DRAINAGE SUMMARY

PROJECT : INTERSTATE ROUTE H-3

F. A. I. PROJECT NO: 1 - H-3-(150)

STATE OF HAWAII DEPARTMENT OF TRANSPORTATION HIGHWAYS DIVISION
DRAINAGE PLAN
INTERSTATE ROUTE H-3 F.A.I. PROJ. NO. I-H3-1(50)
SCALE: 1" = 40' DATE: JUL., 1988
SHEET No. H8 OF 54 SHEETS

STATE OF HAWAII DEPARTMENT OF TRANSPORTATION HIGHWAYS DIVISION	
DRAINAGE DETAILS	
INTERSTATE ROUTE H - 3 F. A. I. PROJECT NO. 1 - H3 1(50)	
SCALE: AS NOTED	DATE: FEB., 1990
SHEET No. H38BOF 54 SHEETS

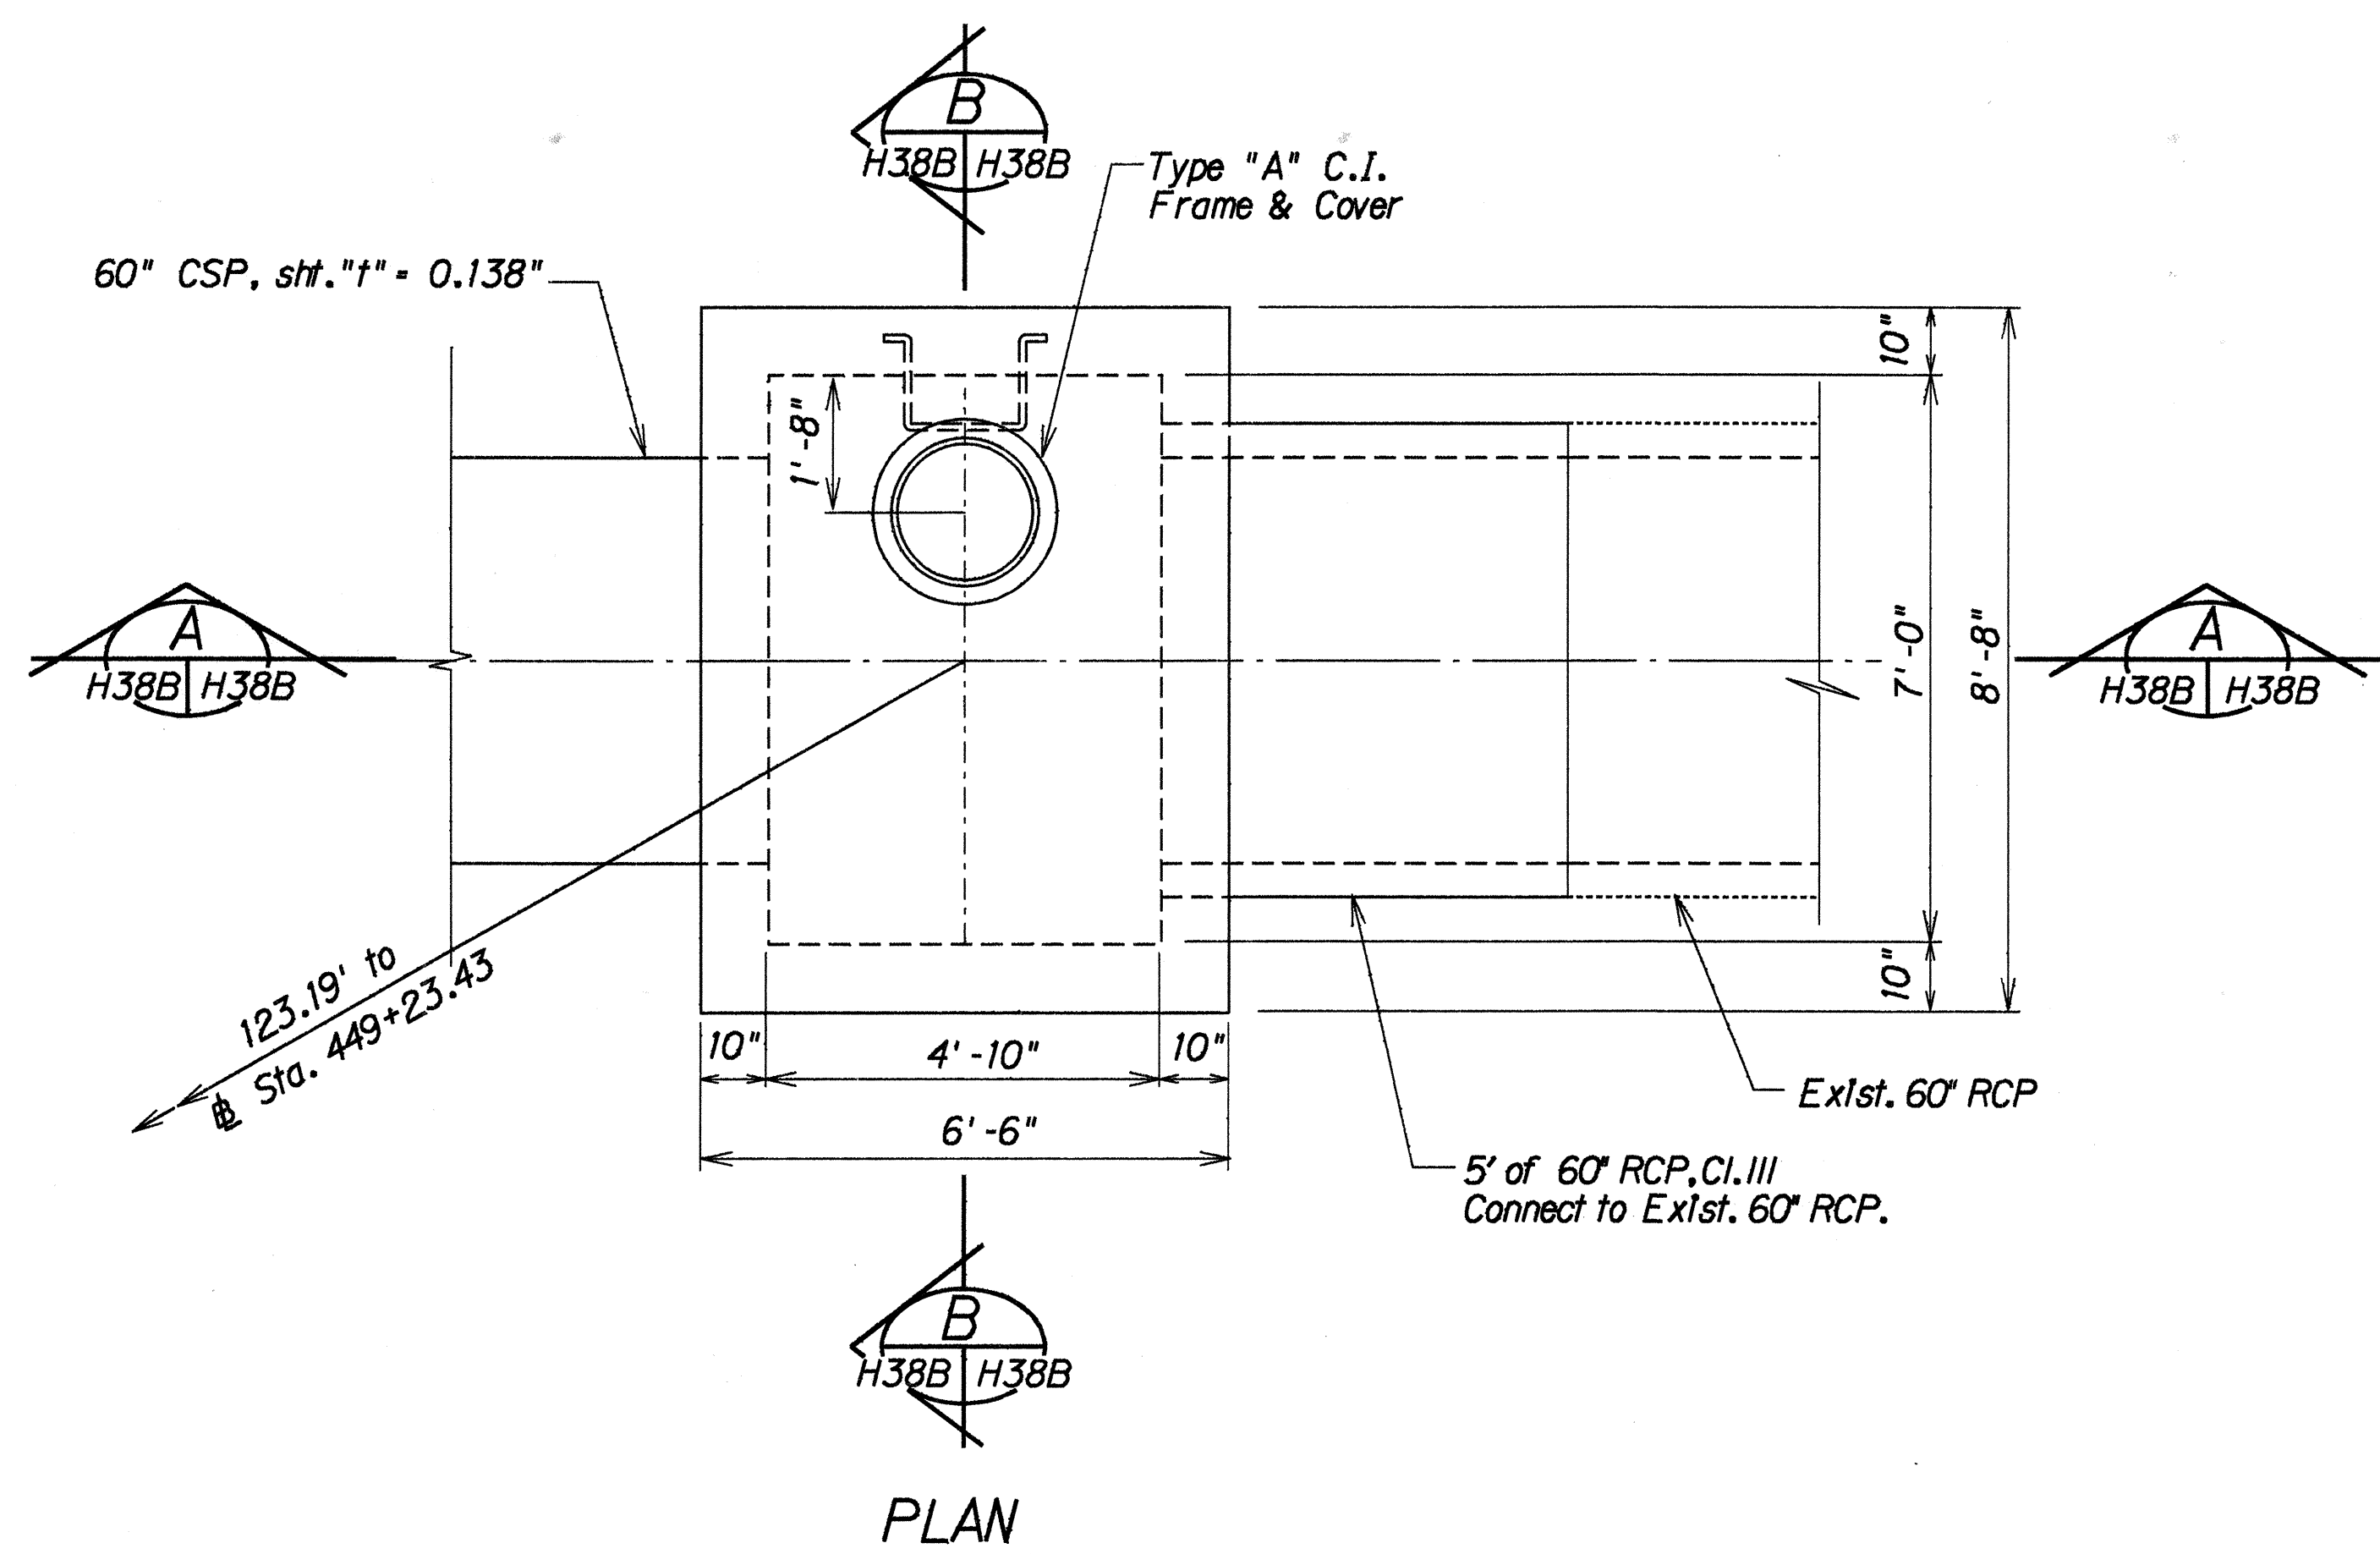
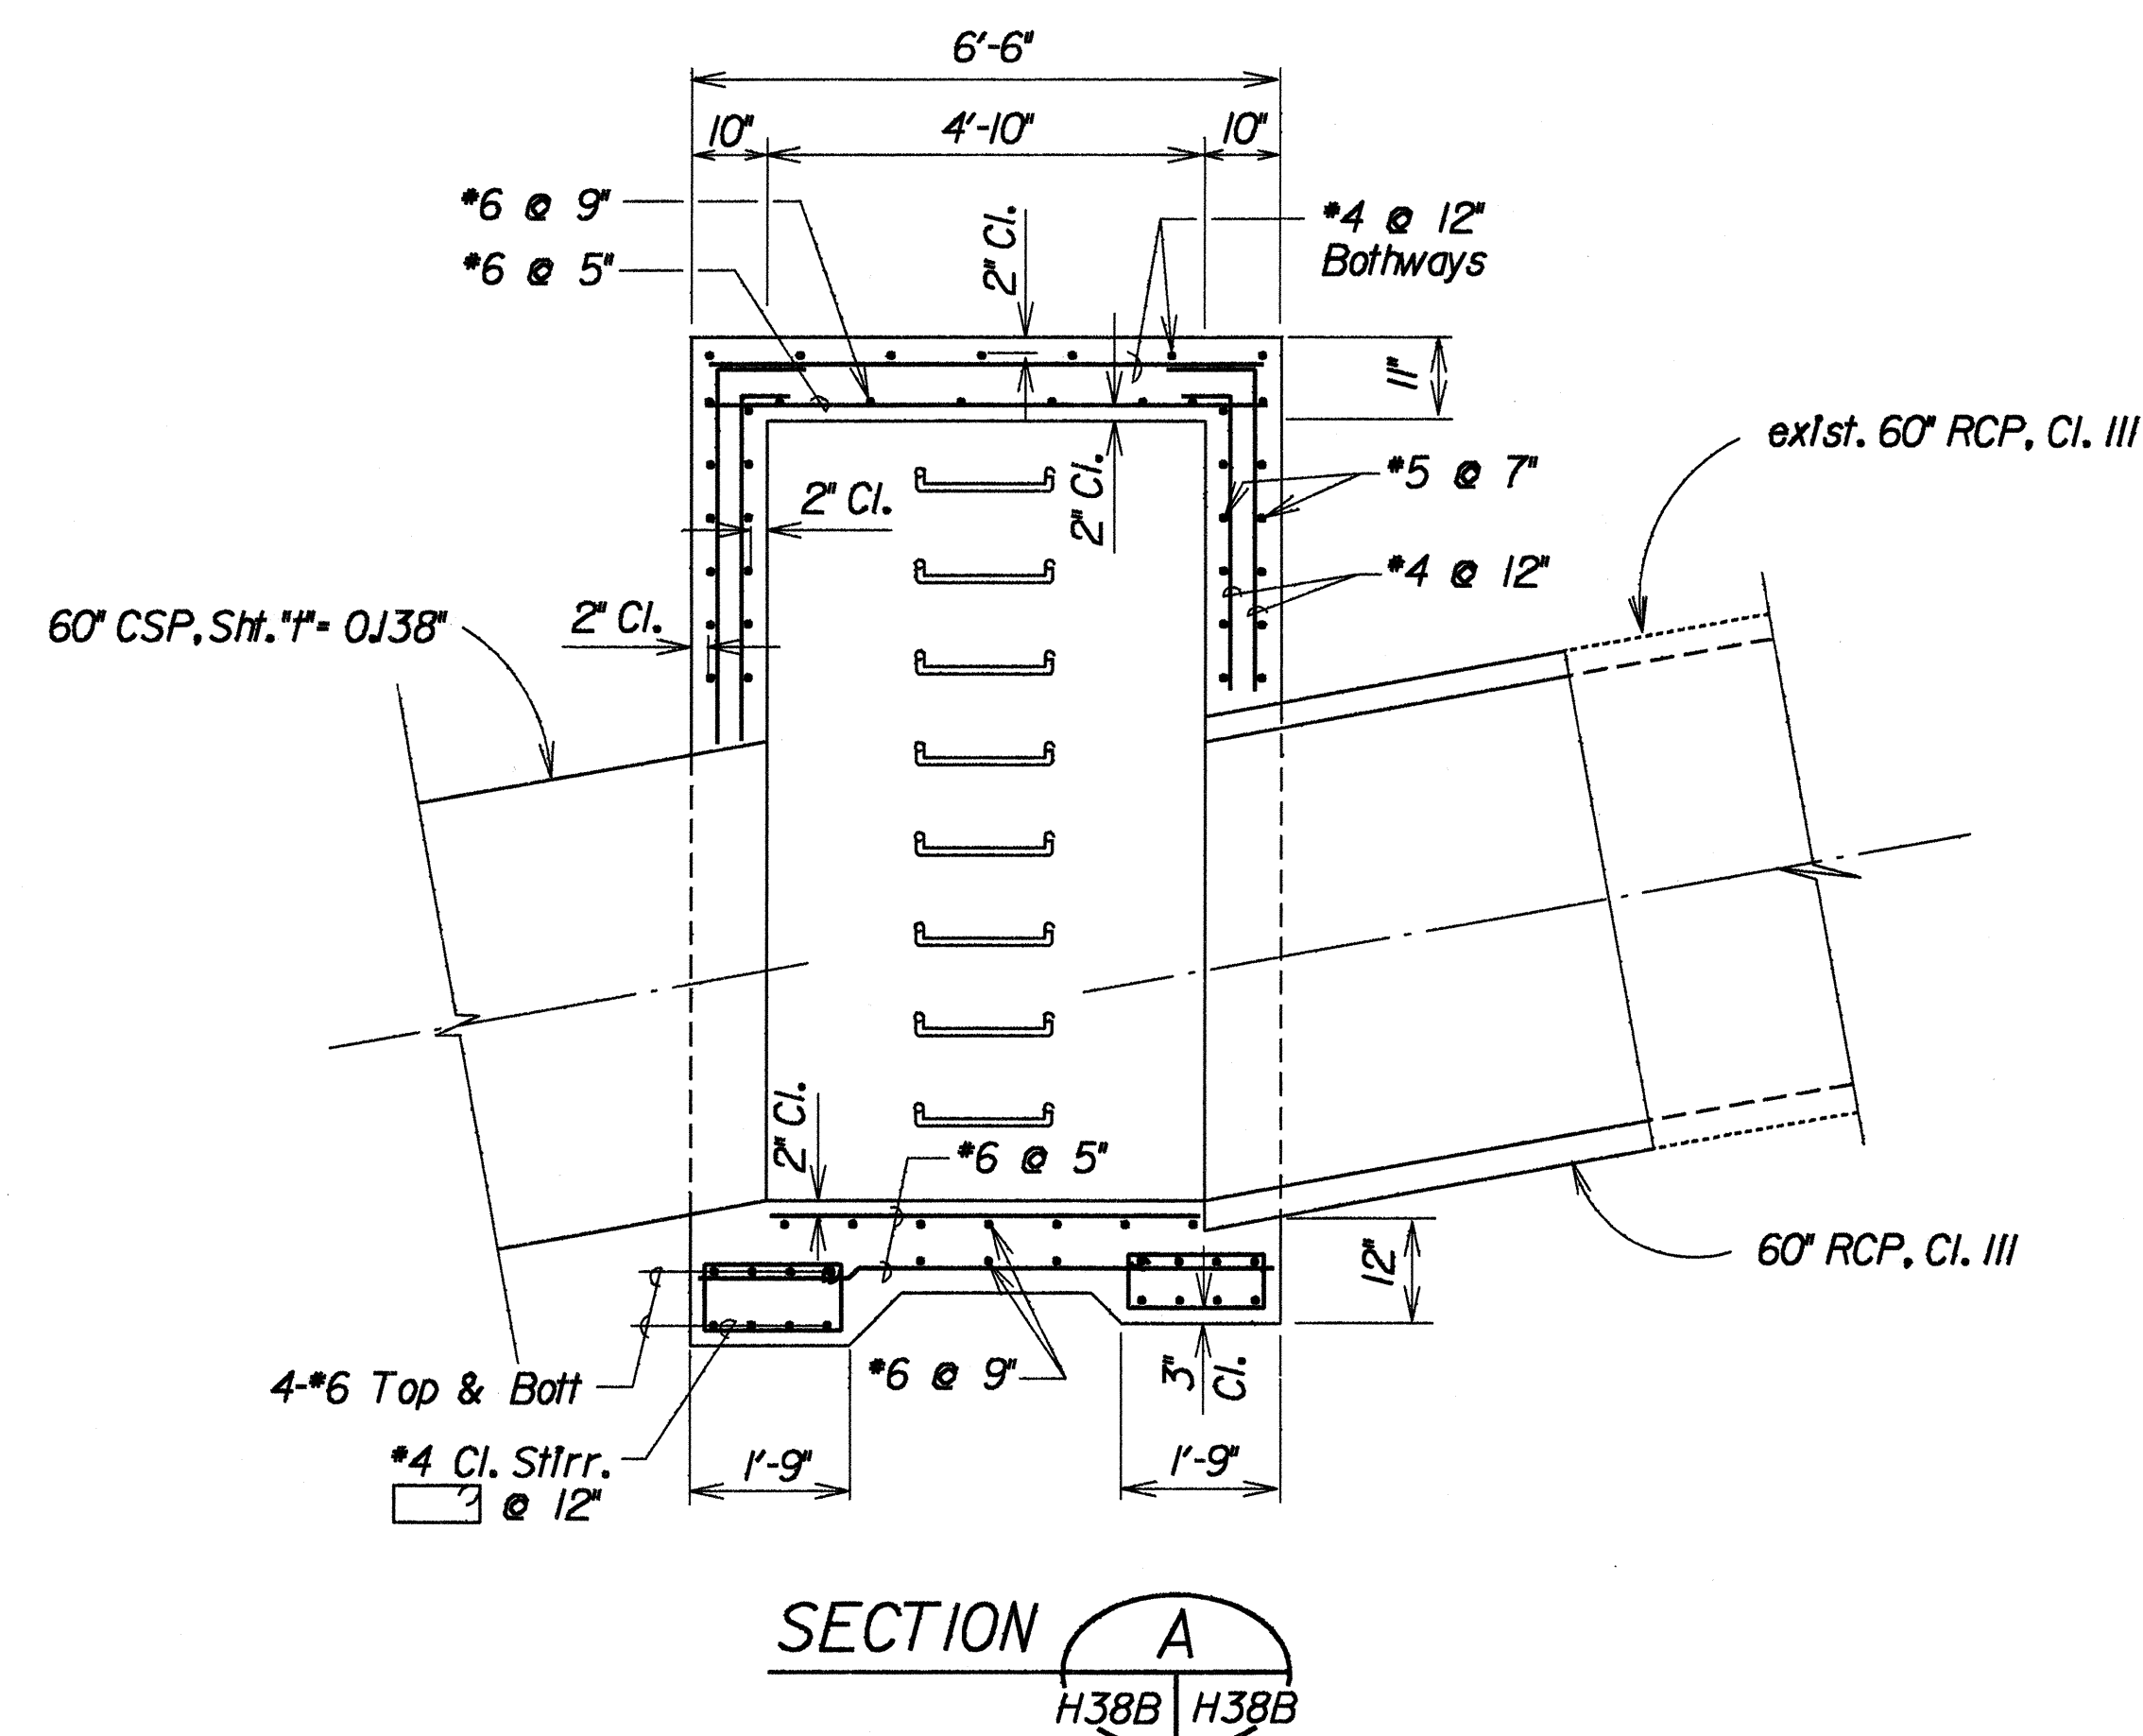
2/14/90	Type G SDMH added as Junction Box between H3 and Golf Course
DATE	REVISION

INLET STRUCTURE AT STA. 453+39 o/s 62.5' RT.

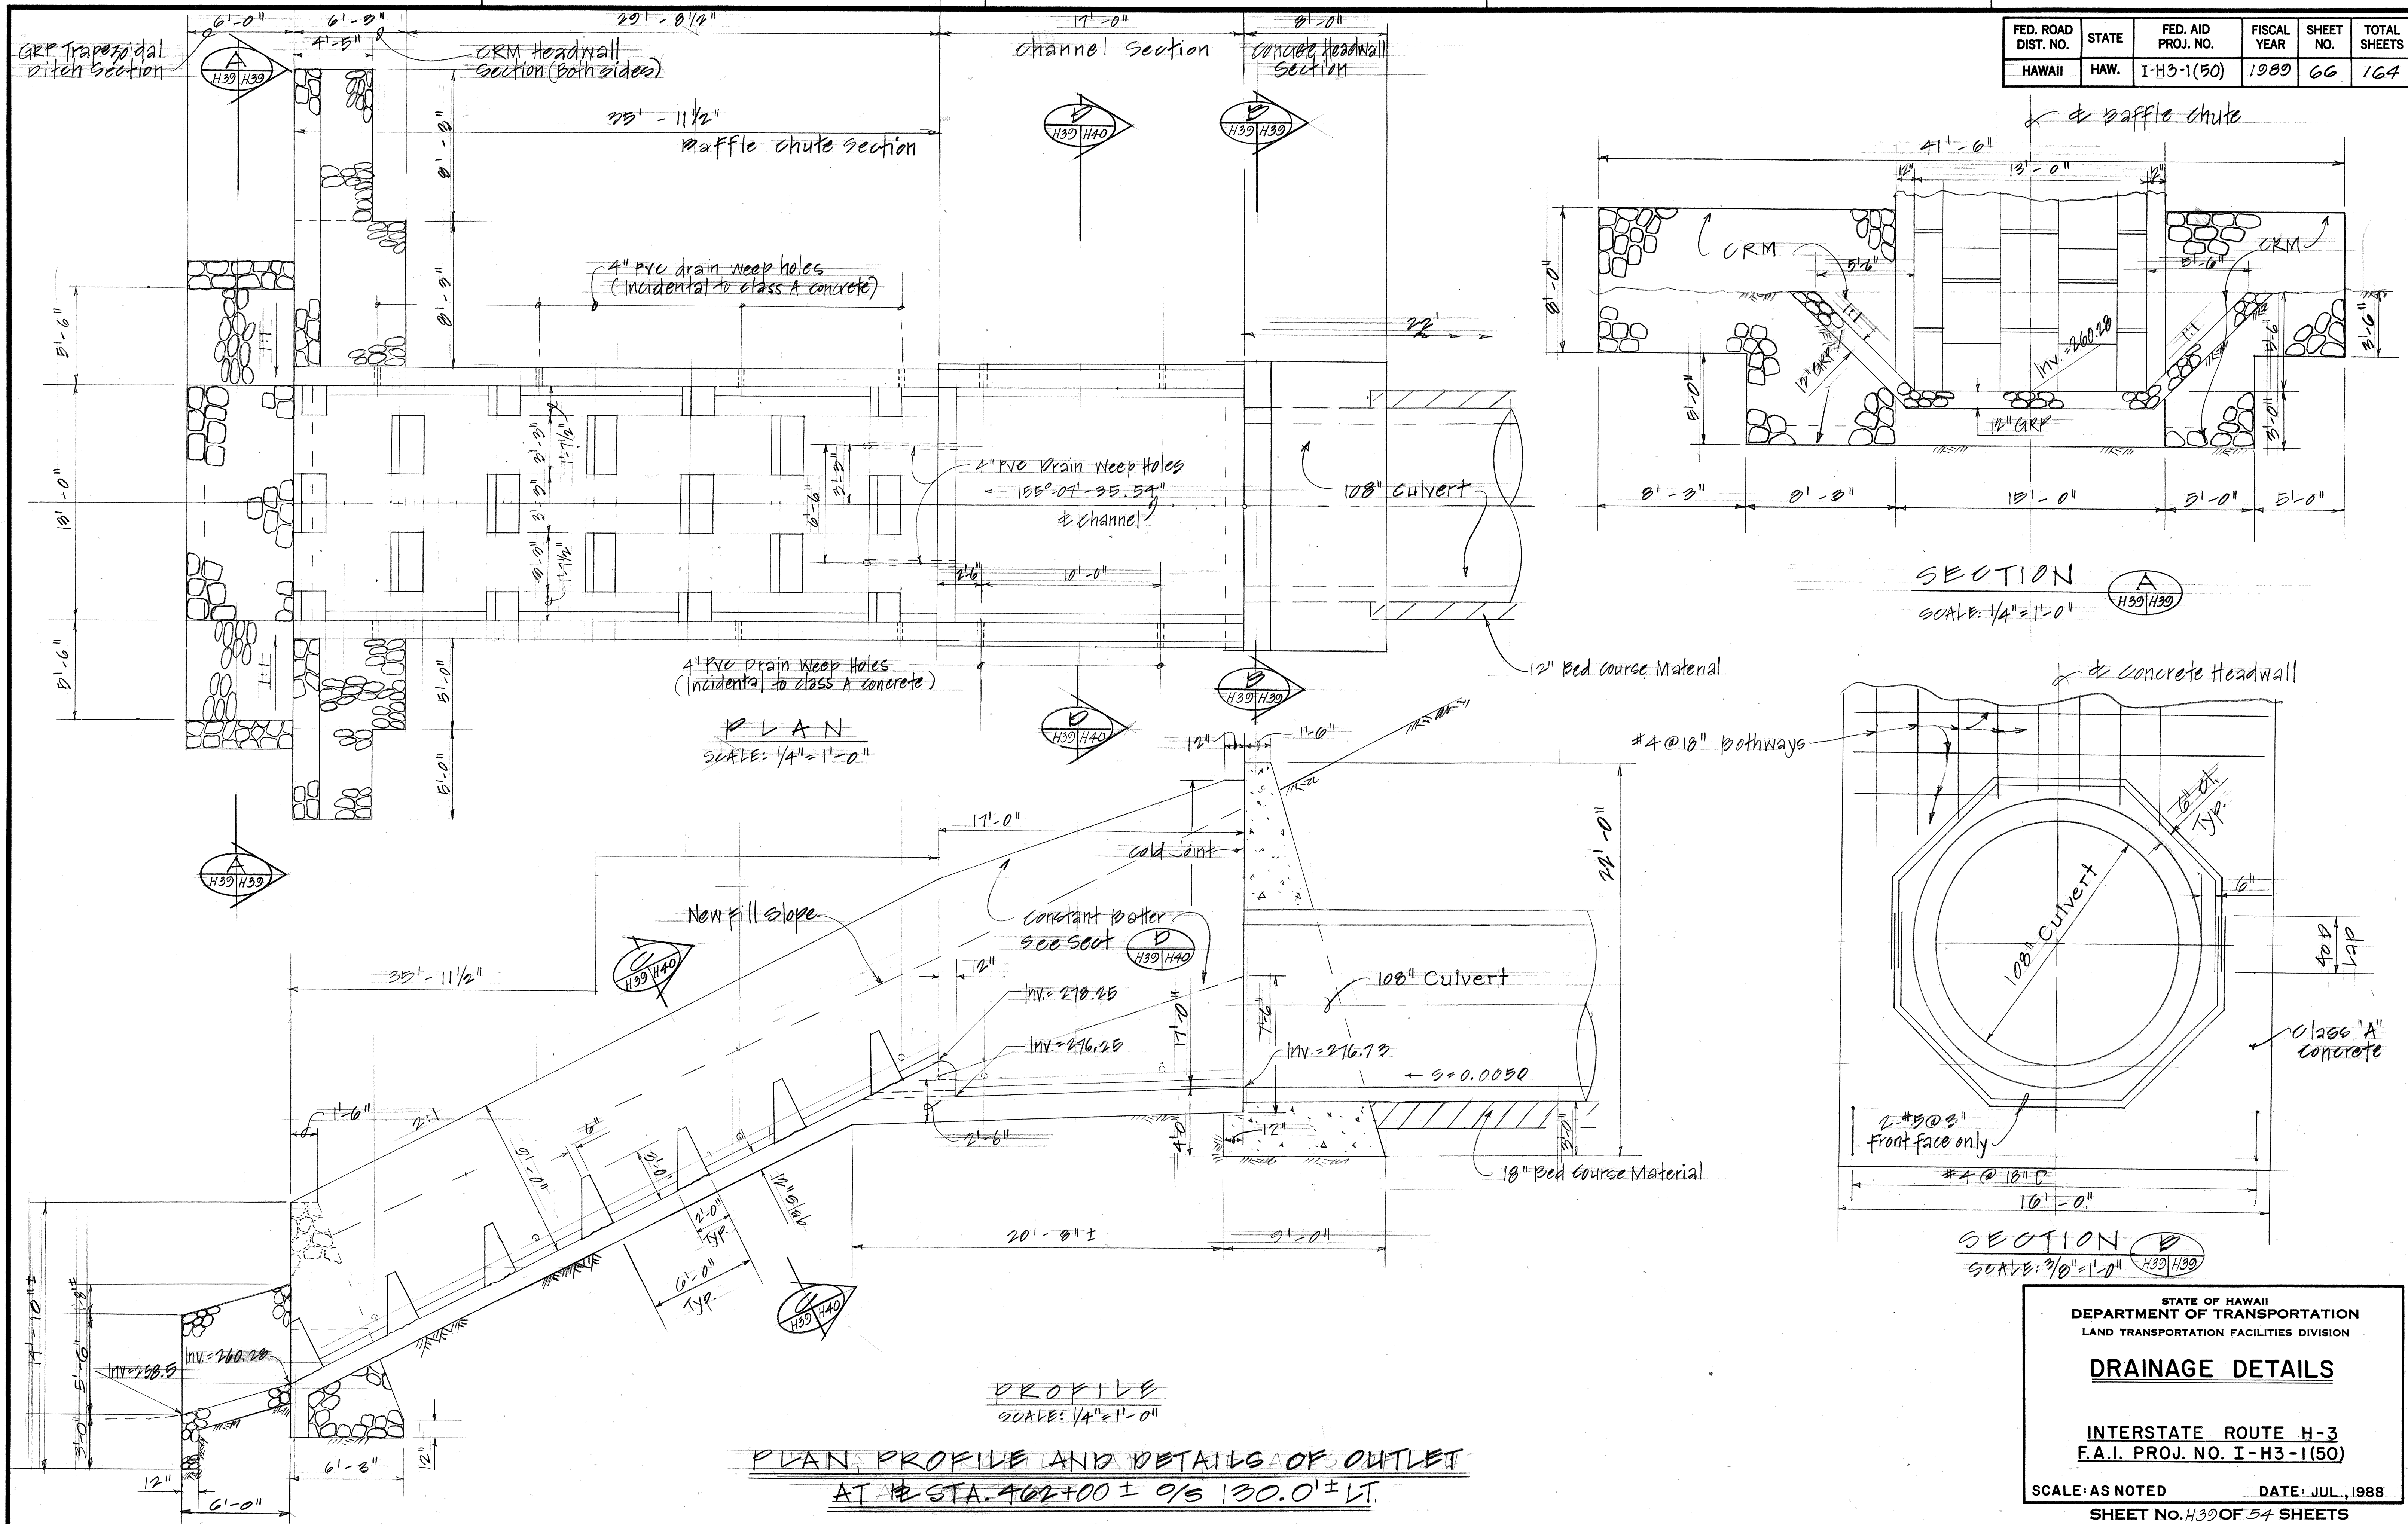
11/07/90	Inlet extension @ Sta. 453+39 o/s 62.5' Rt.
DATE	REVISION
